PHILCO RADIO-PHONOGRAPH MODEL 49-1404

(Supplement to Service Manual PR-1567, for Philco Radio-Phonograph Model 49-1405)

Wiring Diagram of Record Changer (M-9) in Model 49-1404

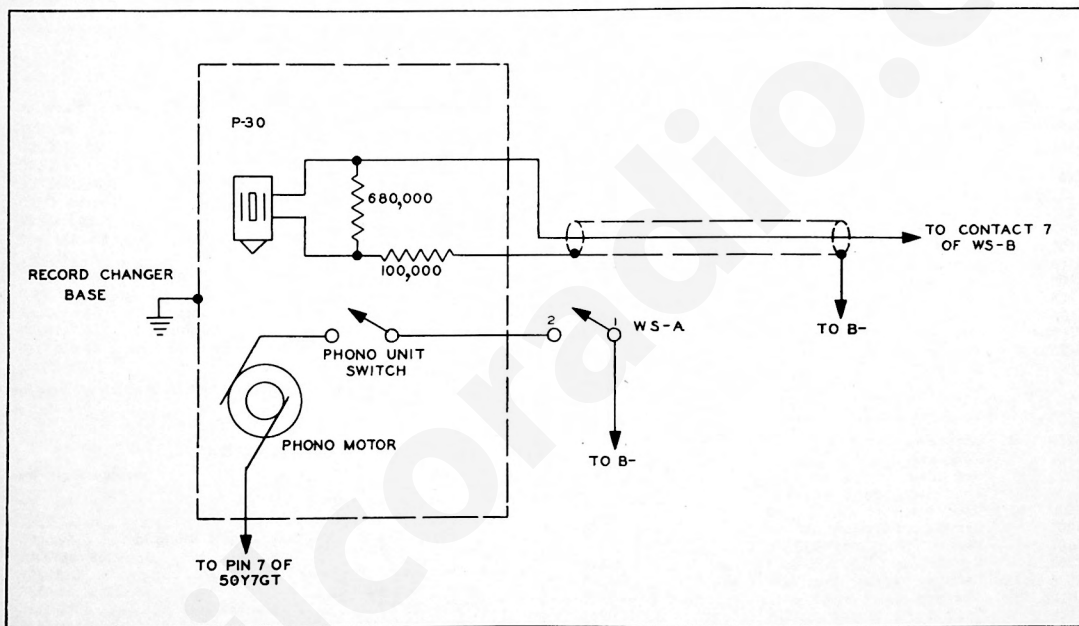
Model 49-1404 is identical to Model 49-1405, with the exceptions given in this supplement. Model 49-1404 uses the Model M-9 Philco Automatic Record Changer; the wiring diagram of this changer is given below, showing the pickup resistor load network. These

resistors are mounted on a terminal strip located underneath the changer motor board. For service information concerning the Model M-9 Automatic Record Changer, consult Service Manual Page 493.
